# **EVALUATION OF HIGH TEMPERATURE GAS COOLED REACTOR FUEL PARTICLE COATING FAILURE MODELS AND DATA**

**Office of Nuclear Reactor Regulation  
U. S. Nuclear Regulatory Commission**

Michael Tokar

Core Performance Branch  
Division of Systems Safety  
U. S. Nuclear Regulatory Commission  
Washington, D. C. 20555

Fig. 20. Assumed effect of a rapid thermal excursion from 1250° to 1400°, 1550°, 1700°, or 1800°C on pressure vessel failure in BISO ThO<sub>2</sub> fuel as a function of (a) fast neutron exposure or (b) kernel burnup (From Ref. 3).

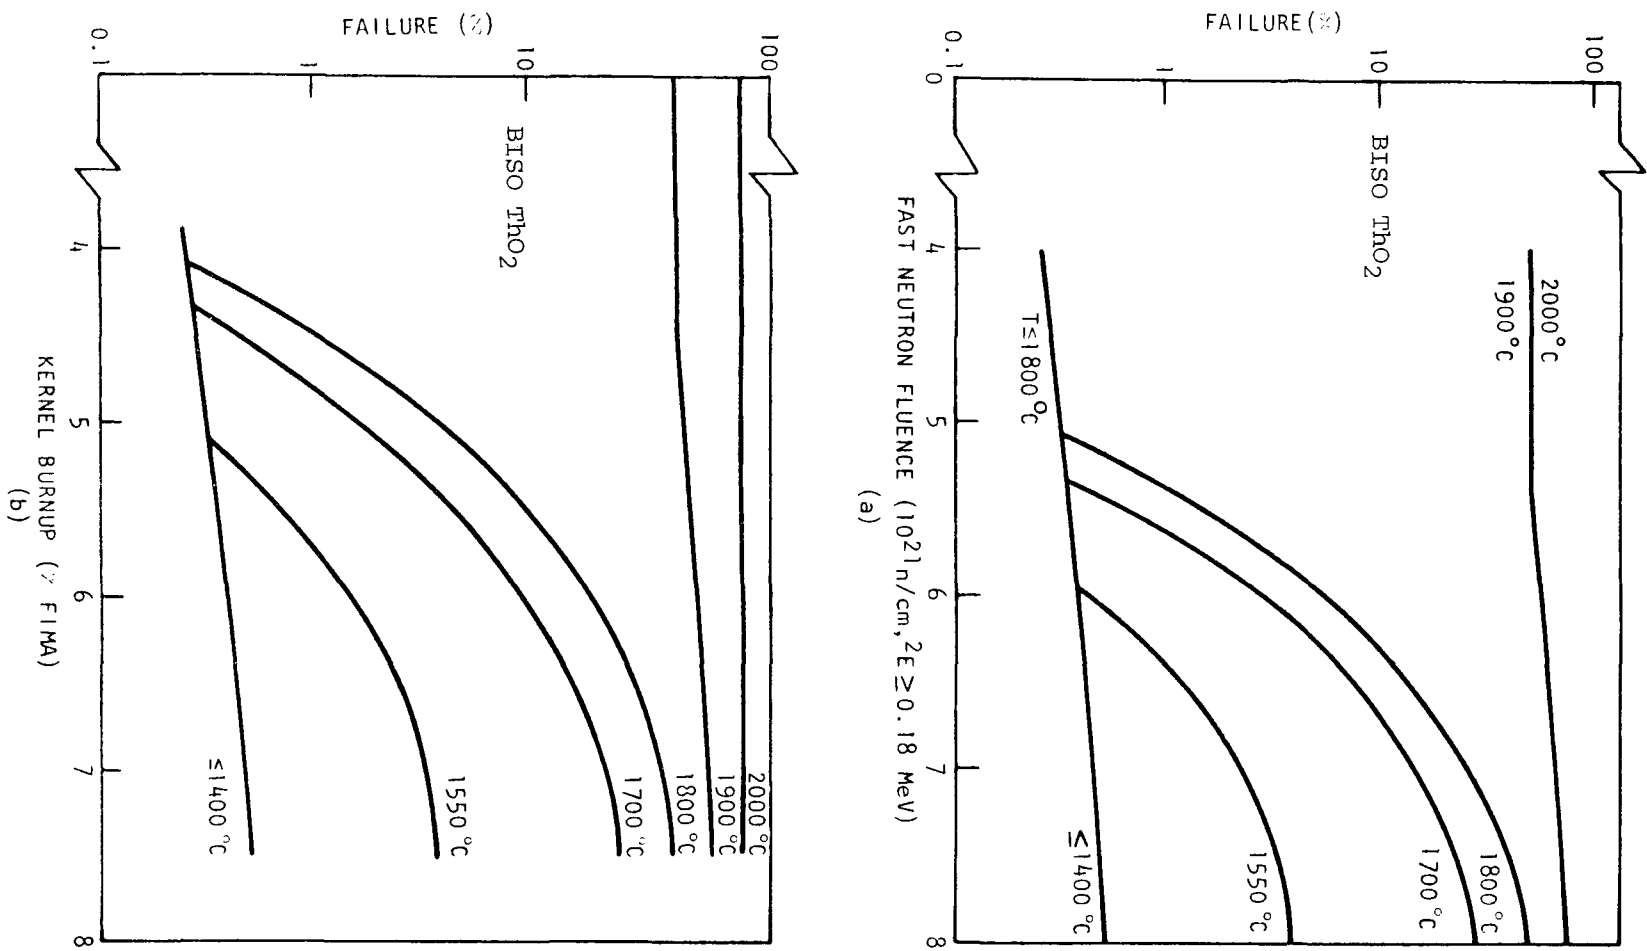
Although GA shows plots of fuel failure (by pressure vessel effects) versus fluence and burnup (Figs. 17a and 17b) in GA-A12971 for temperatures to 1800°C (included in the report as figure 20a and 20b), GA acknowledges that above normal operating temperatures pressure vessel failure may be influenced by fission product attack of the SiC layer, resulting in an increased failure rate which cannot be correlated with the 30,000 psi SiC failure stress. At temperatures >1600°C, therefore, General Atomic proposes to augment the pressure vessel failure model by a model for fission product attack of the SiC.

Fig. 21. Particle failure observed as a function of temperature during isothermal heating of irradiated TRISO carbide fuels for times less than 200 hr. (From reference 3)

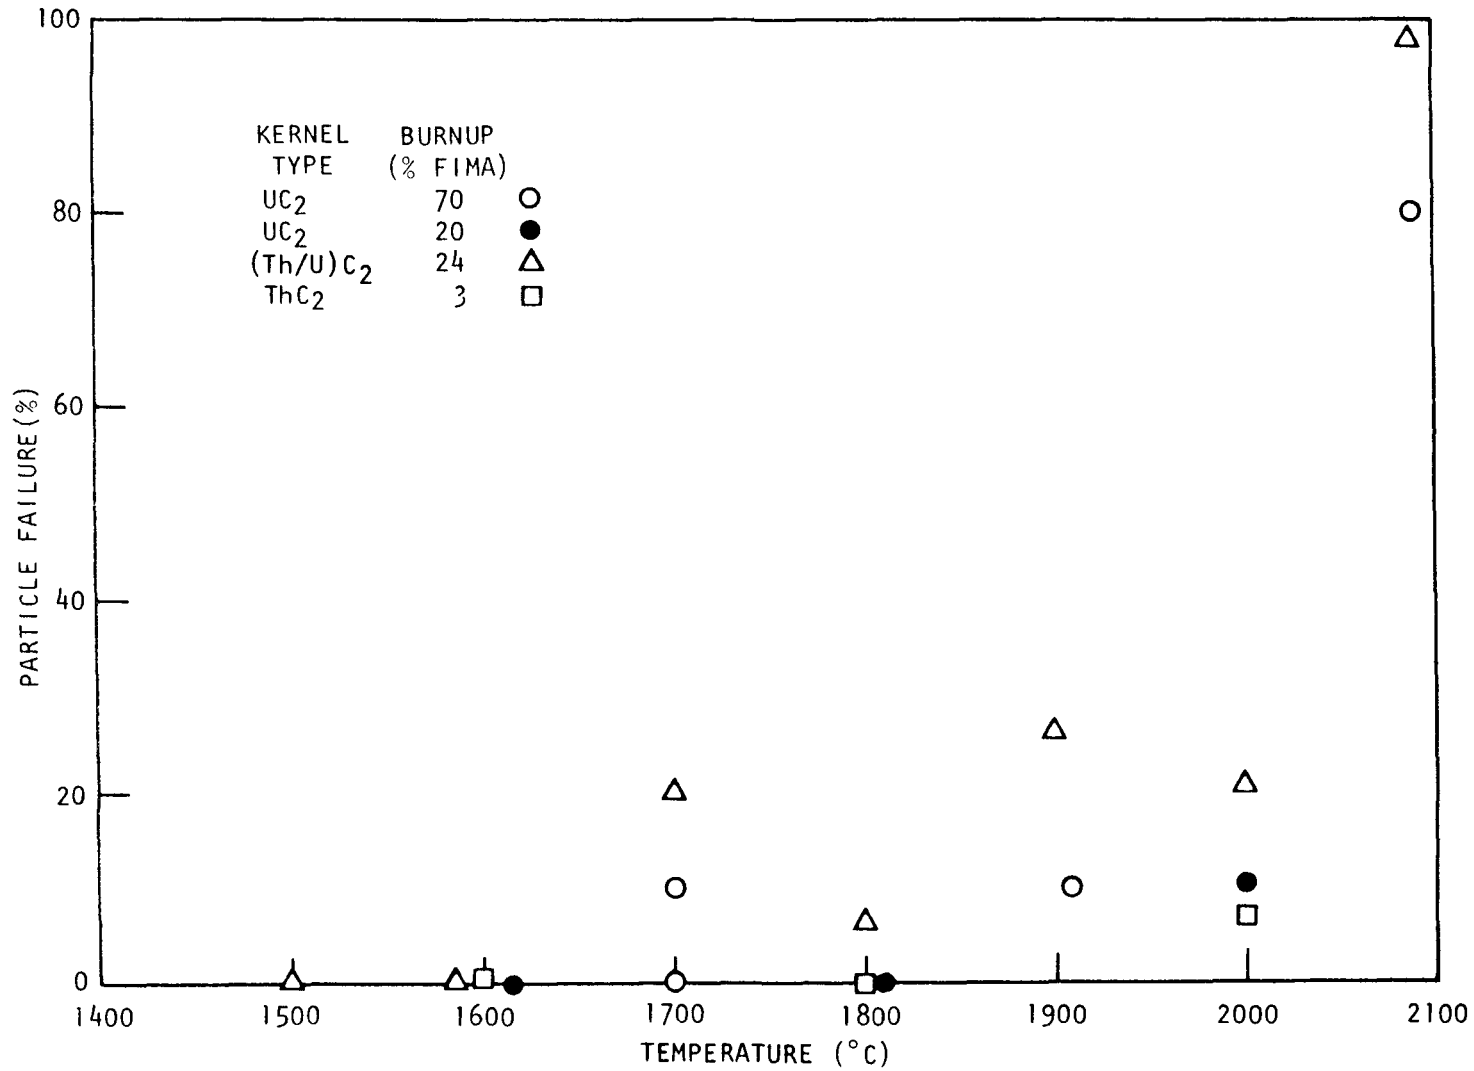
experiment. Failure was detected by visual examination and gamma counting. Comparison of the data in figure 21 with pressure vessel performance predictions, shown in figures 19a and 19b, indicates that using the pressure vessel predictions alone to predict the failure of fuel experiencing temperatures in excess of 1600°C after irradiation to nearly peak burnup/fluence conditions at a lower temperature results in an under-estimate of the fuel failure fraction. This may result from the fact that at temperatures above ~1500 to 1600°C, SiC-fission product chemical interactions weaken the SiC layer, thereby rendering it susceptible to failure at stresses below the nominal 30,000 psi failure stress. Alternatively, it may indicate that the 30,000 psi failure stress rule is not intrinsically correct.

We agree with General Atomic that there are insufficient data at present to provide a description of the SiC-fission product reaction kinetics. Using the body of data presented in figure 12 of reference 3 (also presented in attached Fig. 21), we have, therefore, attempted to bound the data in a suitably conservative way, taking into account the nature of the failure mechanism, the existing sparsity of data, and the gaps in knowledge in current understanding of the exact failure mechanism in terms of the chemical and physical phenomena involved. As discussed below, we have subdivided the failure model into three parts, dealing with peak burnup (78% FIMA), "low burnup" (<20% FIMA), and intermediate burnup (>20<78% FIMA) particles.

We do not intend to imply, however, that the data, as presented in figure 21 and described in reference 3 are not without question. Although the data as originally presented was supposed to represent tests conducted at 24 to 100 hours, subsequent discussion with GA revealed that the test intervals were actually 16 to 200 hours. Some samples were heated for 16 hours, examined, reheated, examined, and reheated. The  $UC_2$  1700° sample, however, was not tested at any other temperature. The 1600, 1800, and 2000 °C samples were heated for 200 hours at 1600°C, 100 h at 1800 °C, and 100 h at 2000 °C. Whereas there were only 5 particles per sample tested at 1500, 1700, 1900 and 2100 °C (16 hours), there were 23 (Th, U)C<sub>2</sub> and 28 UC<sub>2</sub> particles tested at 1600, 1800, and 2000°C. Under these circumstances, it is virtually impossible to treat this type of information in a meaningful statistical analysis since the sample populations and test conditions vary markedly and the sample sizes are so small. It is evident that these tests could not have been originally conceived with the purpose of providing statistically meaningful test data for performance modeling.

Figure 23 Incremental particle failure as a function of temperature during heating of irradiated TRISO carbide fuels for times less than 16 hours

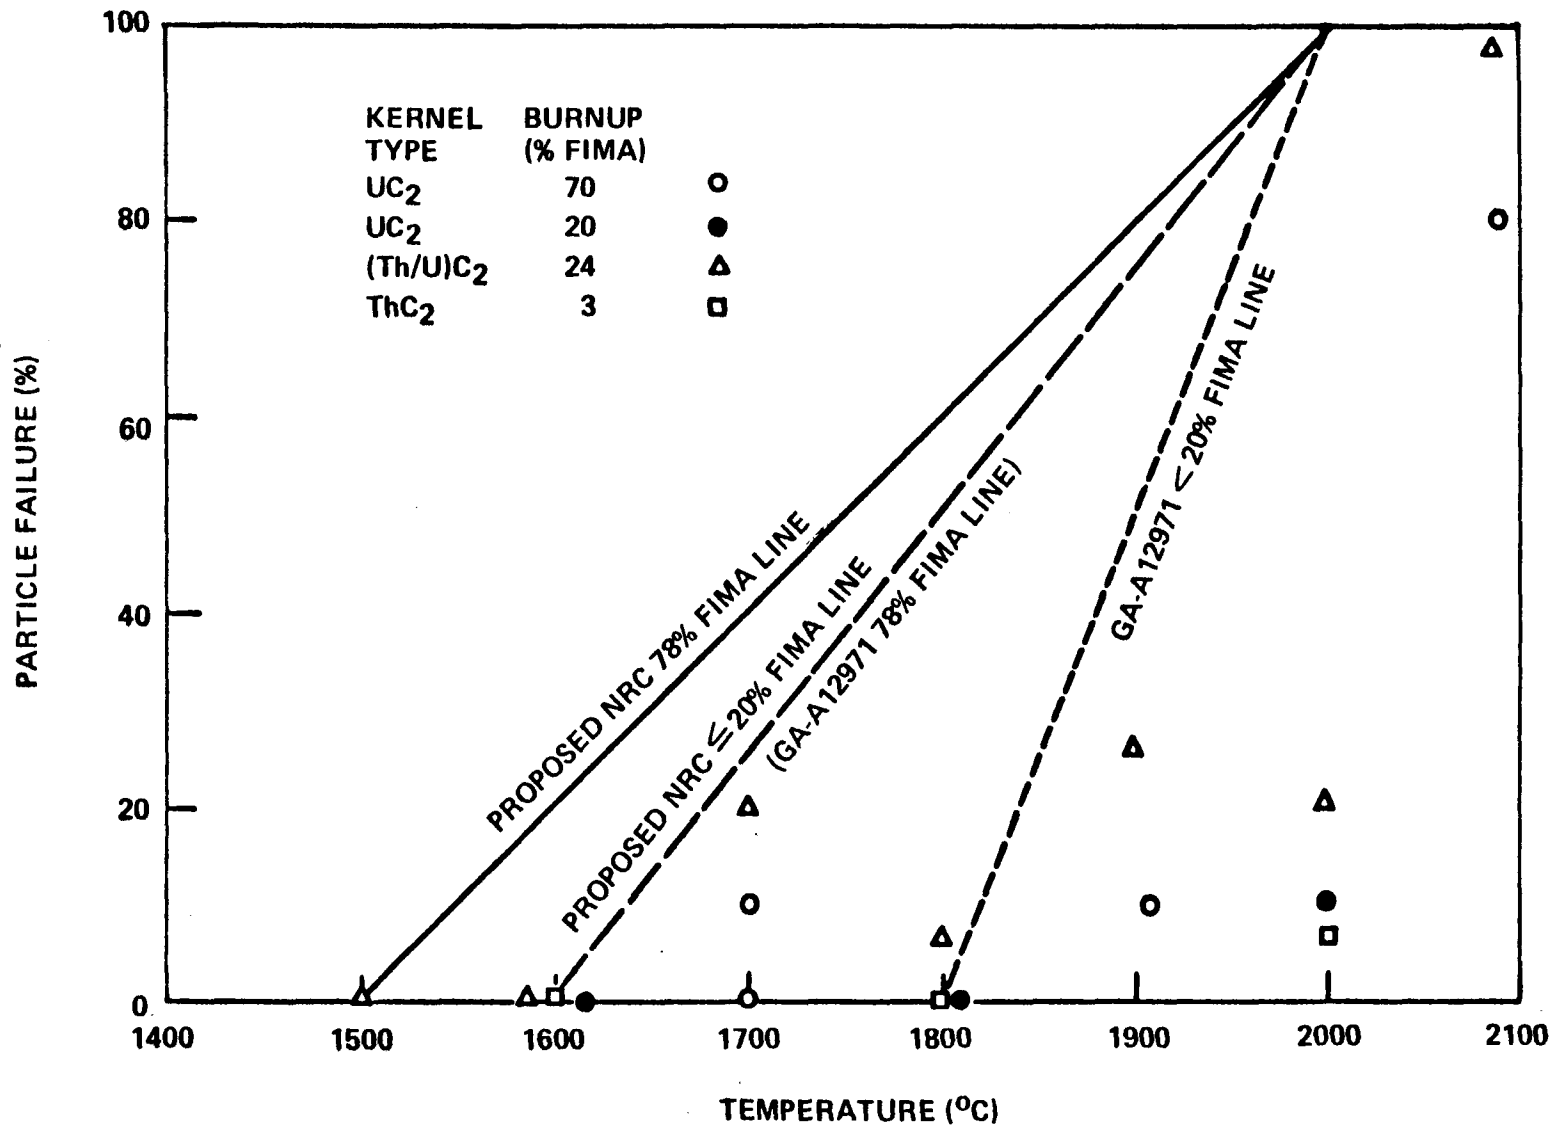
by adding the incremental 16-hour failure fraction to the previous total. A time interval of 16 hours is used instead of 100 hours as recommended by GA, because 5 of the 17 data points in Figures 21 and 23 represent failures detected after 16 hours. The new incremental failure fraction is obtained from the product of the unfailed fuel fraction and the failure fraction determined from Figure 23.

For "low-burnup" (<20% FIMA) TRISO UC<sub>2</sub> particles, we assume that failure increases linearly from the pressure vessel (+ defected fuel + amoeba affect) failure value at 1600°C to 100% at 2000°C, as shown in Figure 23. The lower end of the temperature regime is shifted to 1600°C from the 1800°C advocated in GA-A12971 so as to bound the data for failure of the (Th/U)C<sub>2</sub> particles at 1700 and 1800°C. These data points, the triangles in figures 19 and 23, represent failure of 24% FIMA particles, and should, therefore, be bounded by the line for "low burnup" fuel. In a manner similar to that described in the previous discussion on 78% FIMA fuel, a new increment of failure is assumed to occur each 16 hours, the new failure increment is assumed to occur instantaneously, (i.e., at the beginning of each 16-hour period), and the failure increment is added to the previous total to get the "instantaneous" total.

When estimating fuel performance it will be assumed that figure 23 and Eq. 8 can be used to determine the incremental fraction of fuel failure occurring instantaneously during any temperature excursion. It will be assumed that a new increment of failure occurs each 16 hours and that the total fuel failure fraction is increased at the end of each 16-hour period by adding the incremental failed fuel fraction determined by using figure 23 and Eq. 8 to the previous total.

Figure 27 Incremental BISO ThO<sub>2</sub> Particle Failure as Function of Temperature

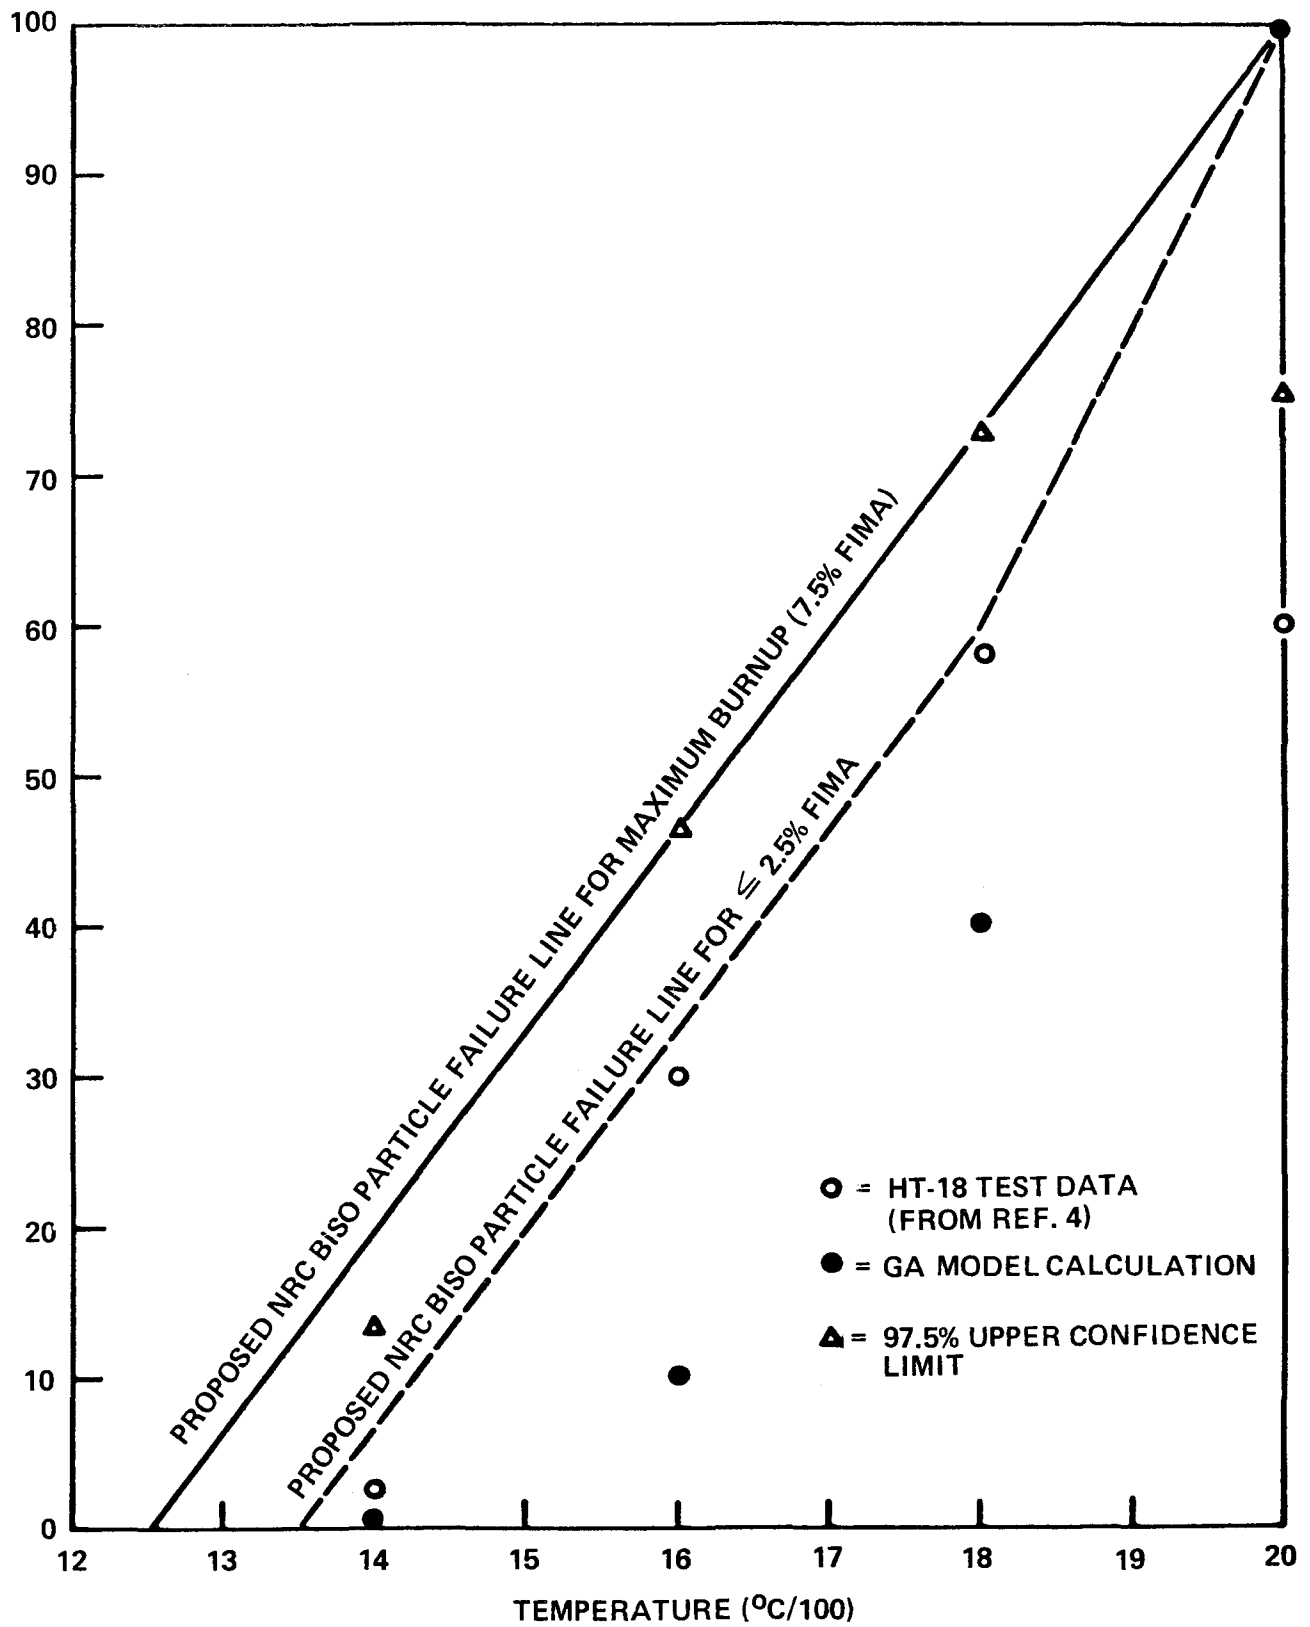
The results of the BISO ThO<sub>2</sub> fuel particle out-of-pile tests, described in GA memorandum #CLS:030:FMB:75, are plotted for high burnup (6.8 - 7.8% FIMA) in figure 27 along with the values predicted by the GA model for BISO fuel. As indicated in the previous discussion, the GA model underpredicted the failure rate except at 2000°C. Hence, to provide a reasonably conservative estimate of BISO ThO<sub>2</sub> fuel failure at high burnup, as a lower bounding set of values, it is proposed that the pressure vessel failure value be assumed to increase linearly from the value for off-specification fuel at 1250°C to 100% at 2000°C. This proposed linear relationship of fuel failure with temperature has a slope nearly parallel to a line drawn through the high-burnup data points at 1400, 1600 and 1800°C (see Fig. 27), and using a confidence coefficient of 97.5%, the 7.5% FIMA line closely follows the 97.5% confidence limit values obtained from the HT-18 capsule irradiation test described in reference 4.

The 7.5% FIMA failure line bounds the data by a substantial margin because the data represent a total of only 40 particles, an average of 10 particles per data point. Until further information is obtained on the effects of transients on BISO fuel it would be unwise to modify the high burnup line to predict lower failure rates. In using figure 27 to predict BISO particle failure it is assumed that failure occurs instantaneously at a given temperature. For the purpose of providing a bounding calculation, it is also assumed that maximum burnup occurs at an exposure of  $8 \times 10^{21} \text{n/cm}^2$ .

The failure model is represented in figure 27 by the dashed line for  $\leq 2.5\%$  FIMA fuel. The line from 1350°C to 1800°C just bounds the high burnup data points and has a slope which parallels the 7.5% FIMA line. For simplicity in the model, it should be assumed that the  $\leq 2.5\%$  FIMA burnup line corresponds to a fast fluence of  $3 \times 10^{21} \text{n/cm}^2$ . Thus, fuel having exposure  $< 3 \times 10^{21} \text{n/cm}^2$  should be treated as fuel with  $\leq 2.5\%$  FIMA in predicting BISO fuel failure unless another correlation is provided, as in GASSAR Section 2A (Ref. 1). (See Table IV).

For particles at peak burnup (7.5% FIMA), pressure vessel failure is assumed to increase linearly from the value for off-specification fuel (2% at 1250°C) to 100% at 2000°C. The increase in pressure vessel failure will be taken from figure 27 from the 7.5% FIMA line and will be added to the sum of the defective and off-specification fuel failure fractions (2.2% at <1250°C) to get the total failed fuel fraction.

Incremental pressure vessel failure estimates at intermediate burnups will be made by the interpolation. For a given temperature, the pressure vessel failure increment will be taken from figure 27 by assuming that the failure rate increases linearly between 2.5% to 7.5% FIMA (or 3 to  $8 \times 10^{21}$  n/cm<sup>2</sup>, if the neutron fluence exceeds burnup).
